Energy & Carbon Management Commission

Laramie/0993-29-01 #487592 Annotation Report

Laramie/0993-29-01 #487592 Issue Report

16 - Observation

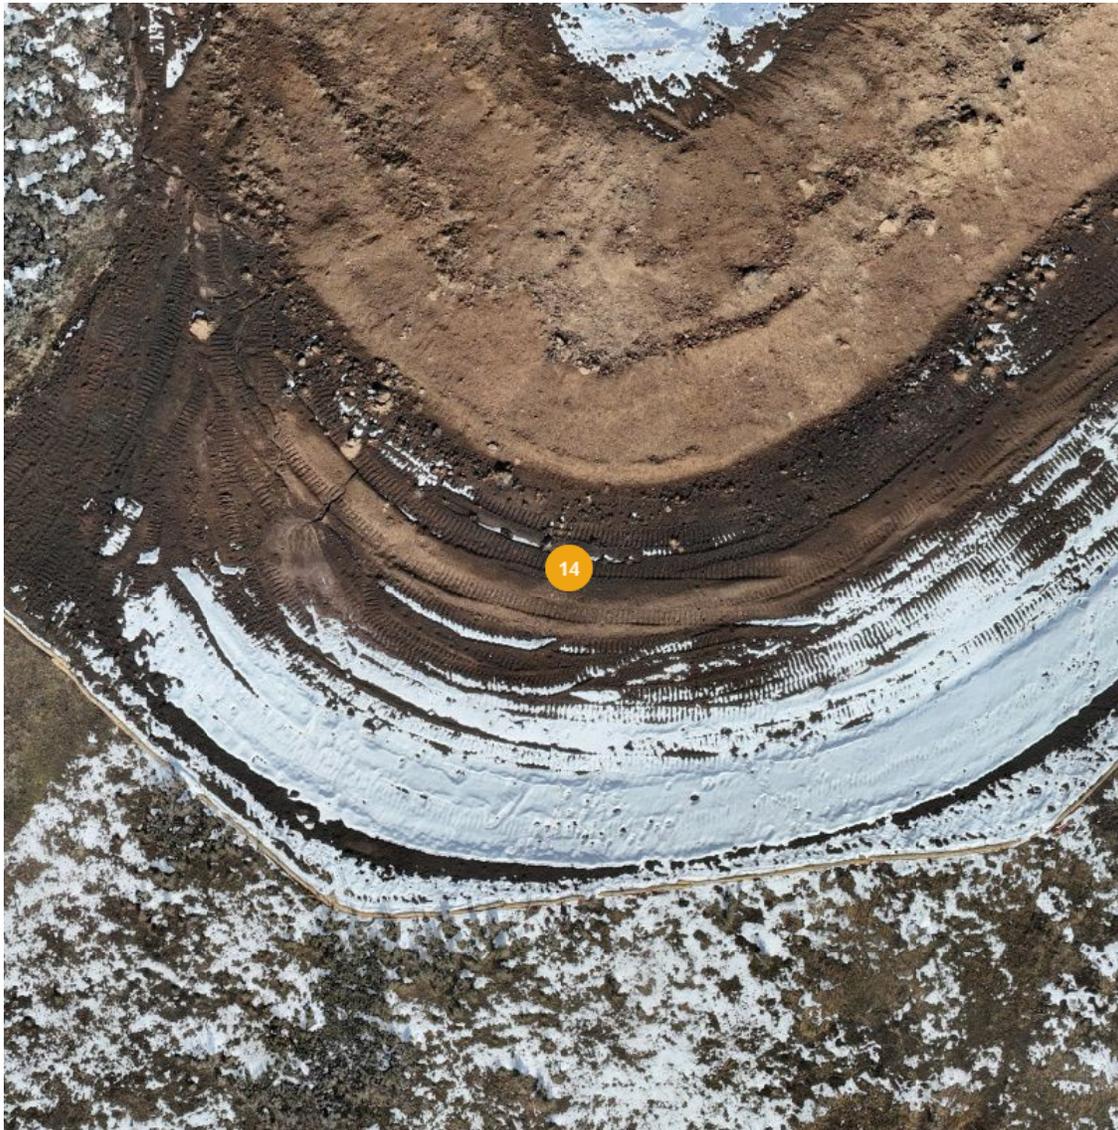
Summary:	Signage has not been maintained and requires posting at the Location entrance.
Created:	Nov 15, 2024, 10:40am by Aaron Trujillo
Cost of Repair:	—
Lat/Long:	39.2529688, -107.7830474
Northing:	1525151.3 US ft
Easting:	2353566.4 US ft
Elevation:	-1.76 US ft

14 - Observation

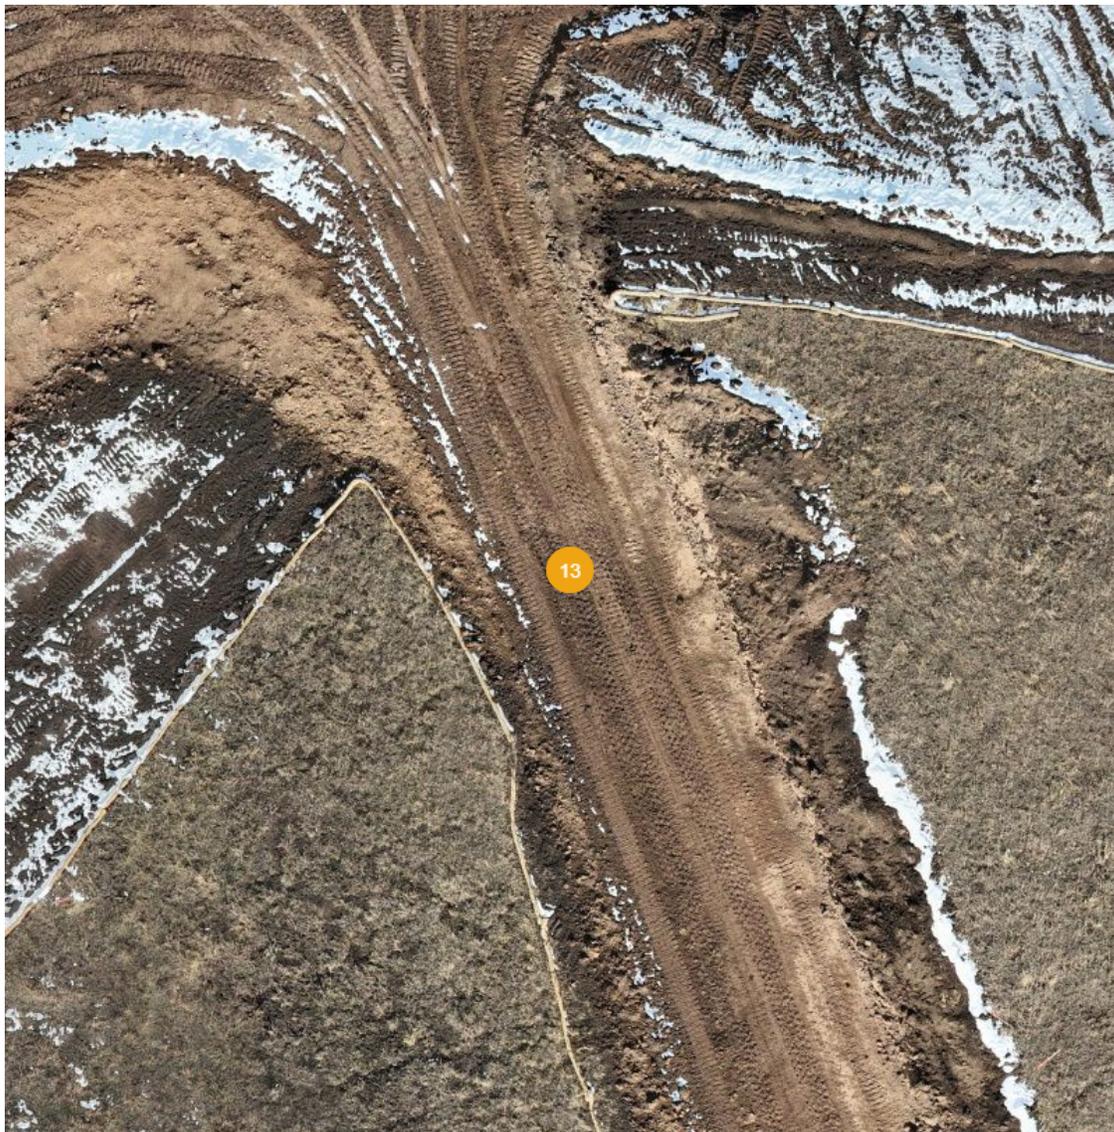
Summary: Sediment trap has not been constructed with engineered inlet/outlet protections per the Form 2A permitted SWMP and Layout Drawing.

13 - Observation

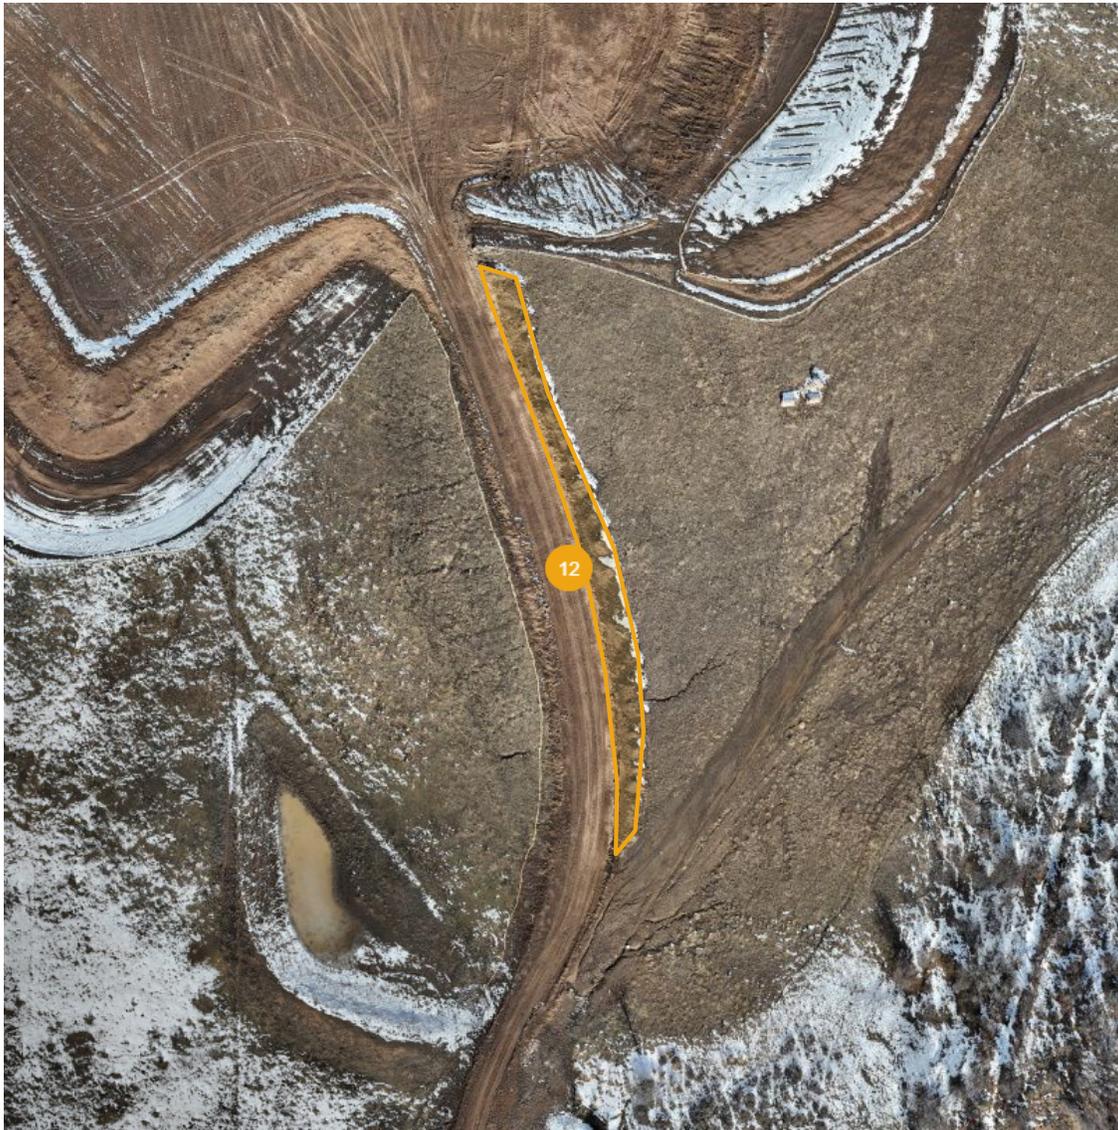
Summary: Working Pad Surface and Access road lacks stabilization. BMPs, including tracking controls, to stabilize, as well as to minimize degradation, tracking and transport of sediment are missing or insufficient.

12 - Observation

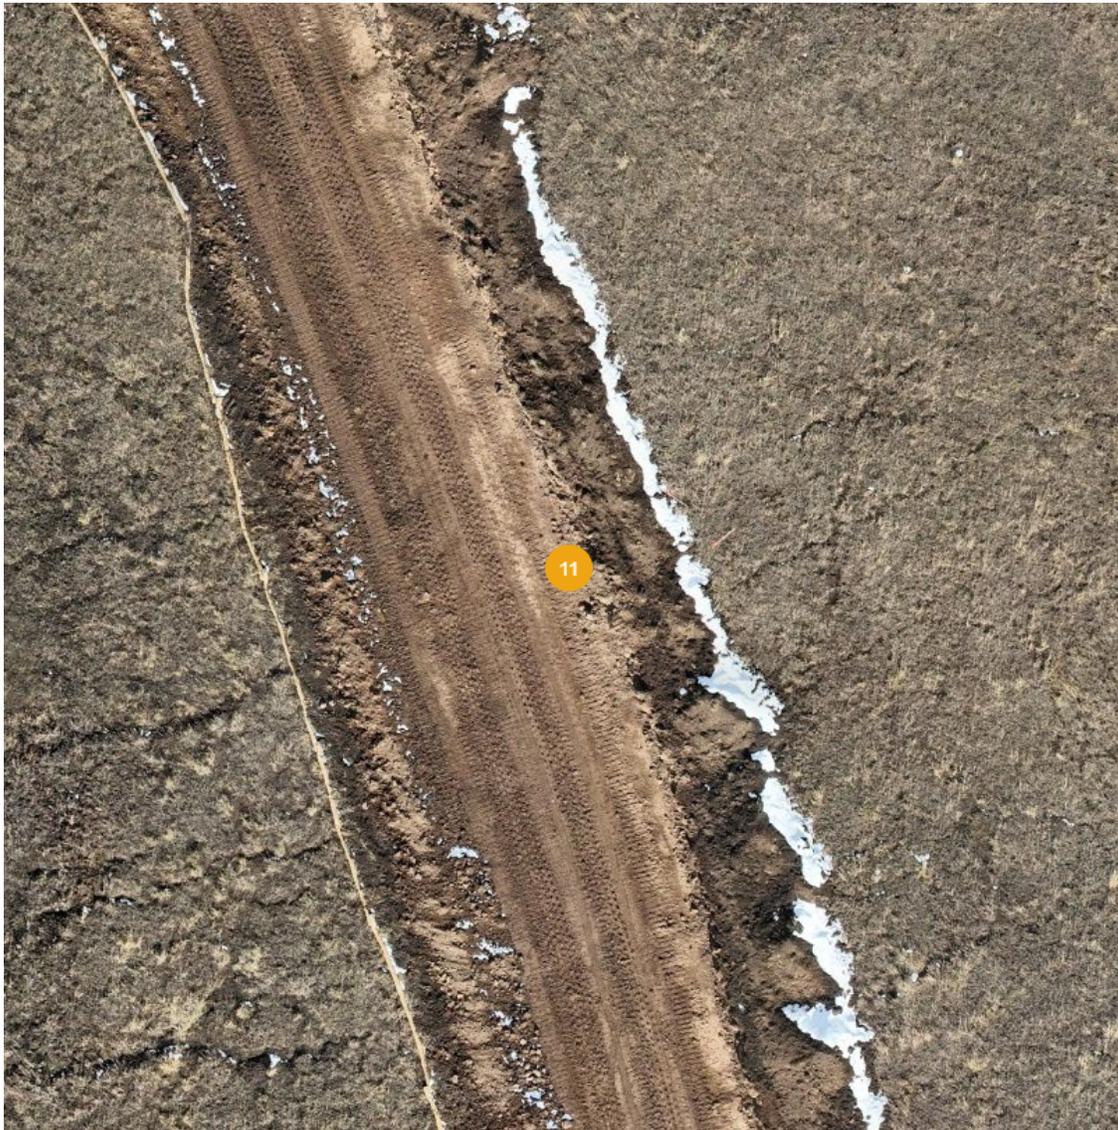
Summary:	BMPs to minimize erosion, degradation, sediment transport, as well as to protect the soil stockpile, have not been installed.
Created:	Nov 13, 2024, 12:29pm by Aaron Trujillo
Cost of Repair:	—
Lat/Long:	39.25358, -107.78315
Area:	5036.56 ft ²
Surface area:	6161.69 ft ²

11 - Observation

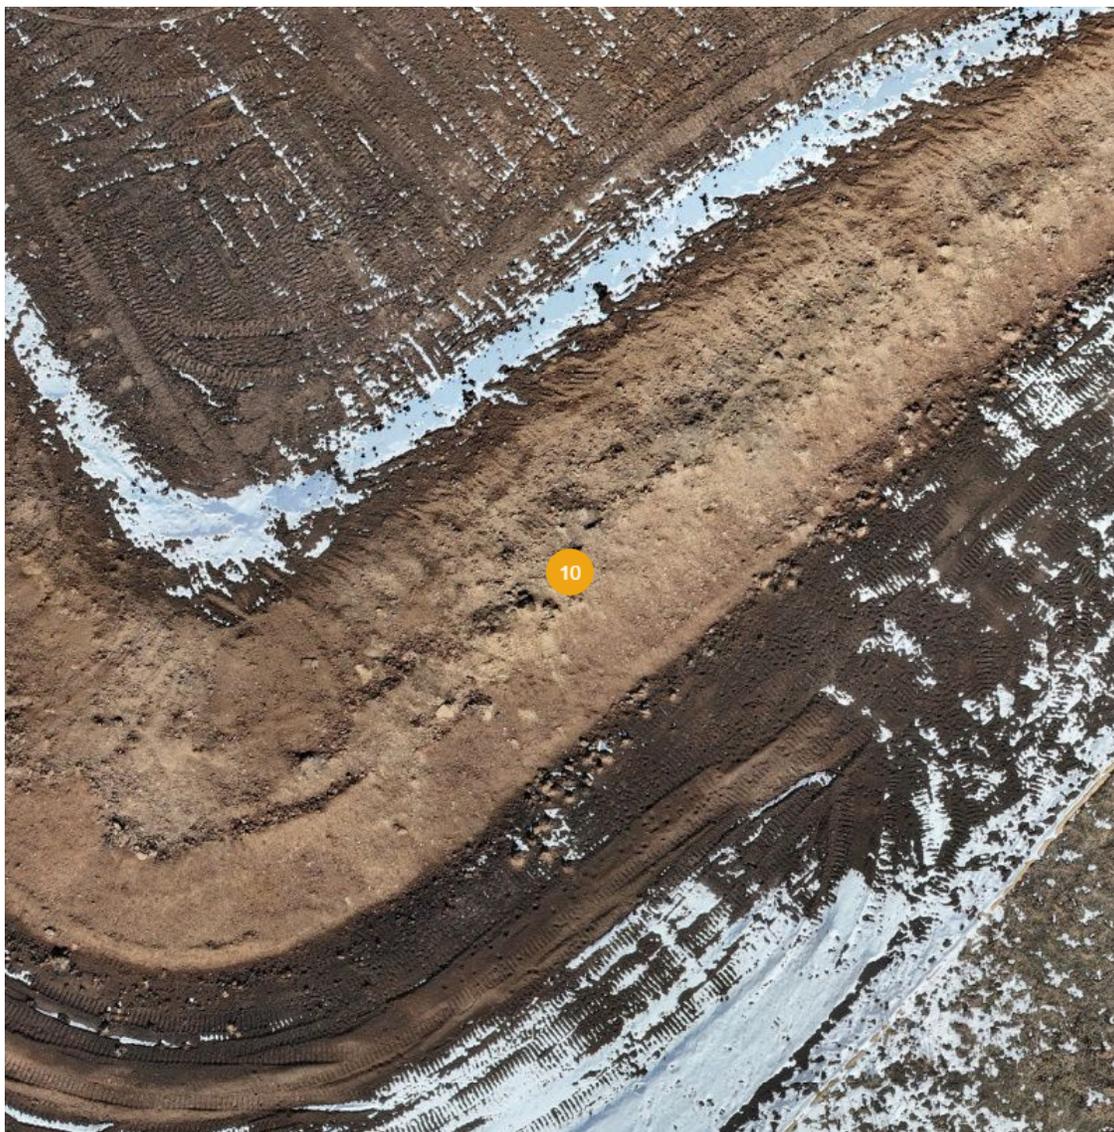
Summary:	Stormwater diversion ditch not constructed along access road per the Form 2A permitted SWMP and Layout Drawing.
Created:	Nov 13, 2024, 12:28pm by Aaron Trujillo
Cost of Repair:	—
Lat/Long:	39.2537222, -107.7832098
Northing:	1525426.7 US ft
Easting:	2353527.4 US ft
Elevation:	4.33 US ft

10 - Observation

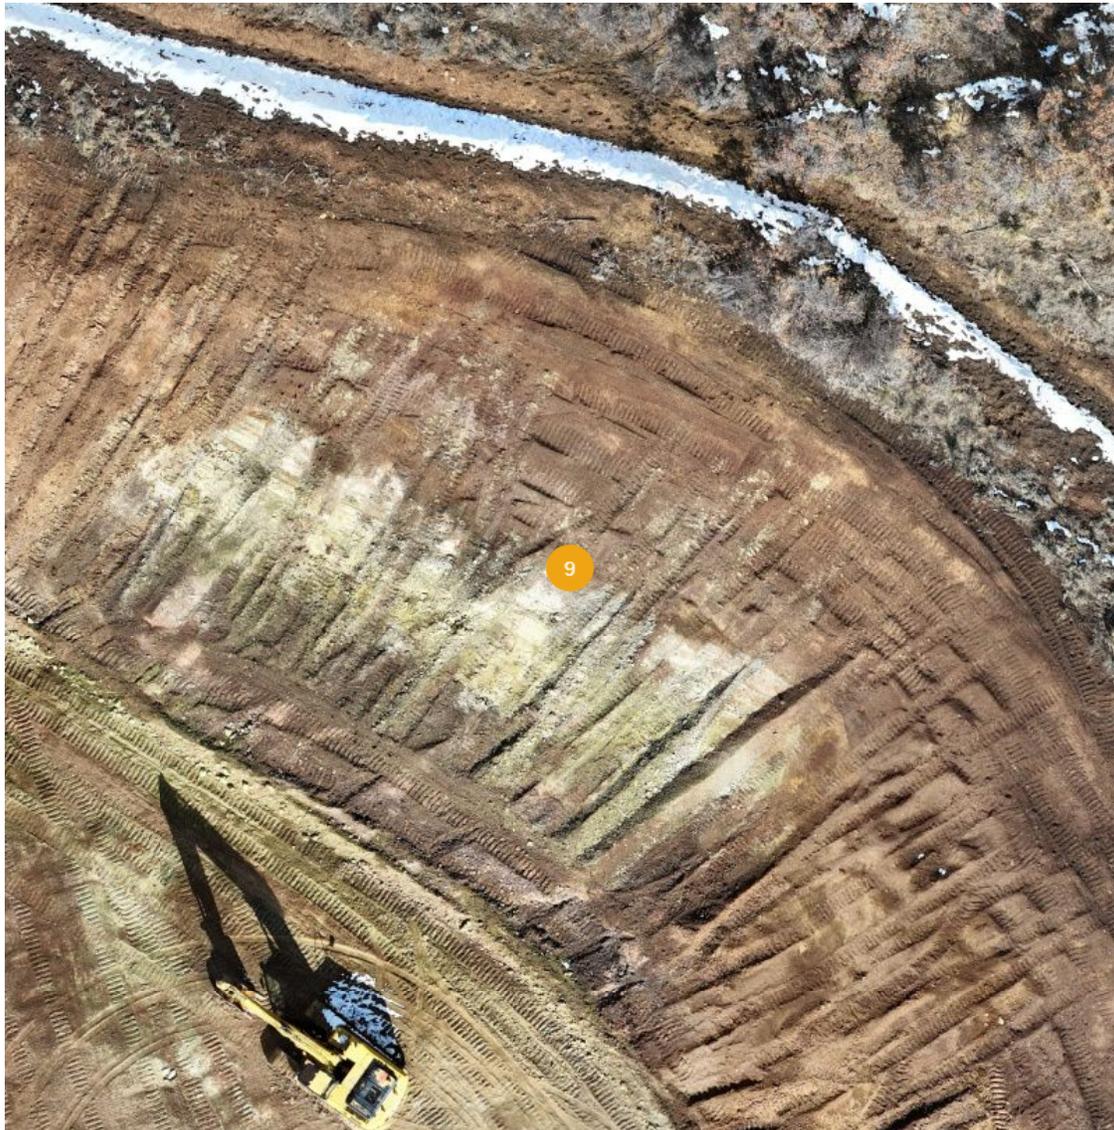
Summary: Fill slopes are bare and exposed soils. BMPs to stabilize, as well as to minimize erosion and degradation are missing or insufficient.

9 - Observation

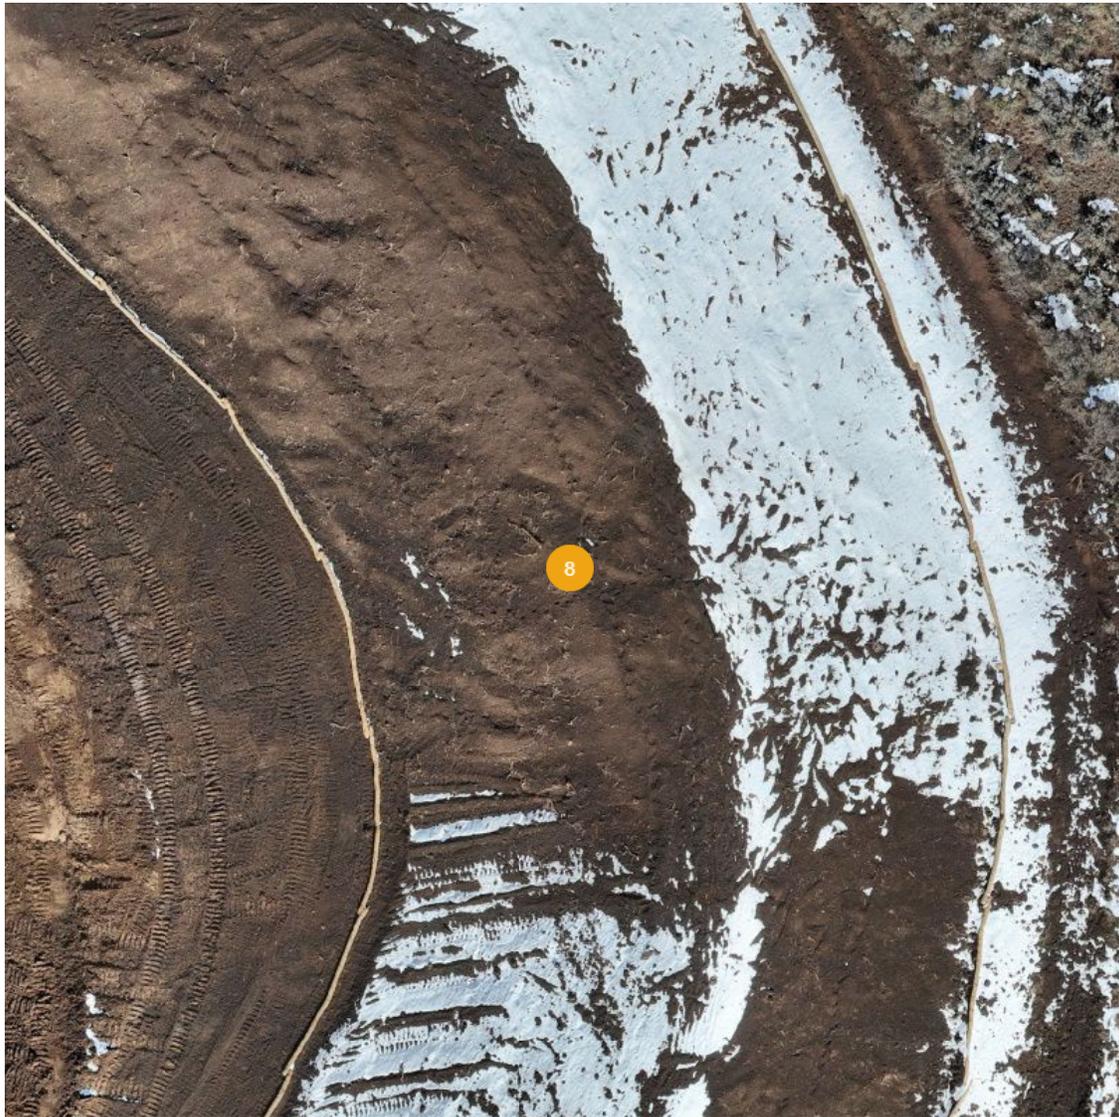
Summary: Cut slopes are bare and exposed soils. BMPs to stabilize, as well as to minimize erosion and degradation are missing or insufficient.

6 - Observation

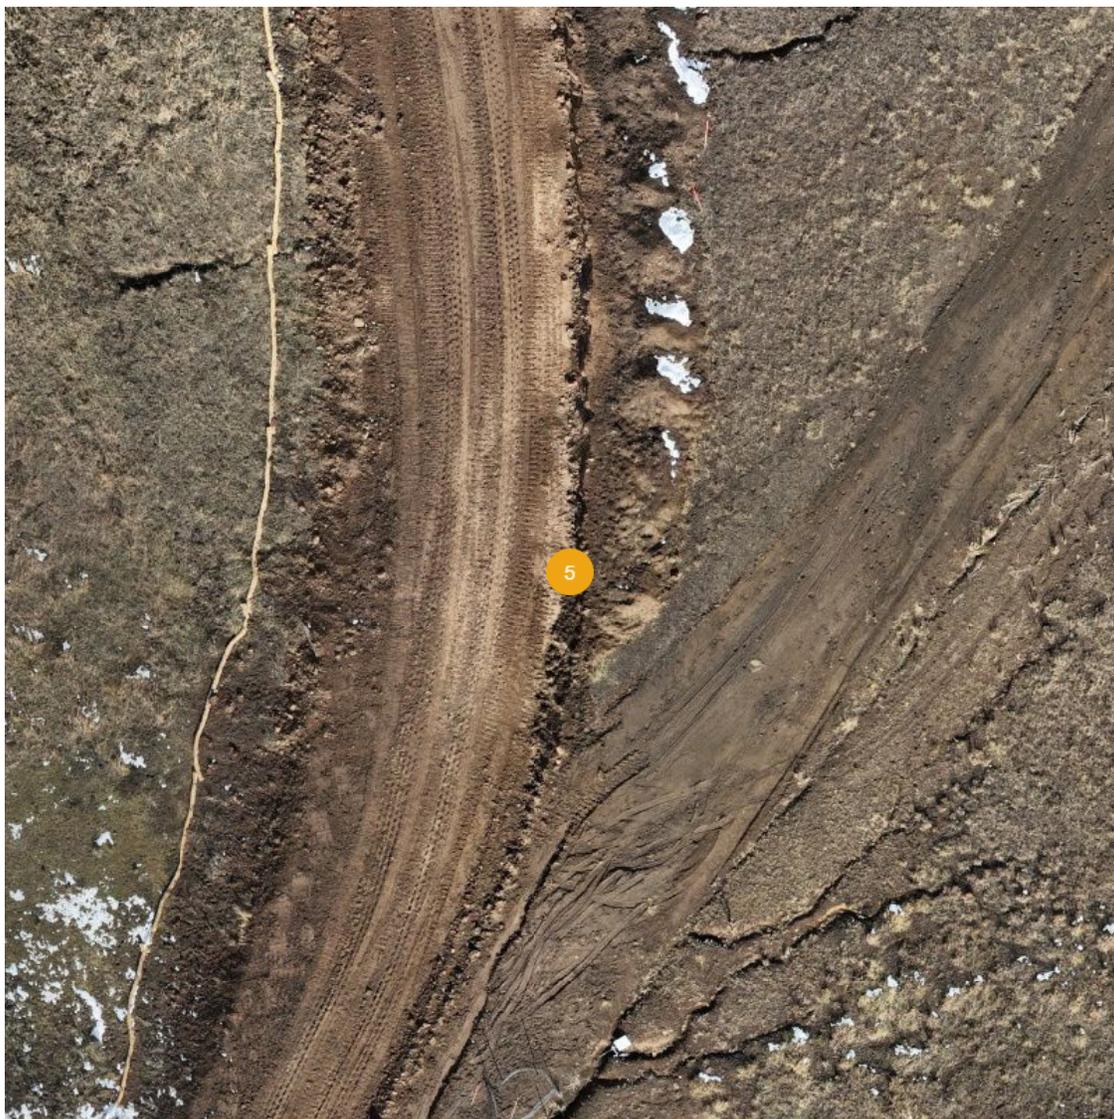
Summary: "V-Ditch" along the perimeter of the Working Pad Surface not installed per the Form 2A permitted SWMP and Layout Drawing.
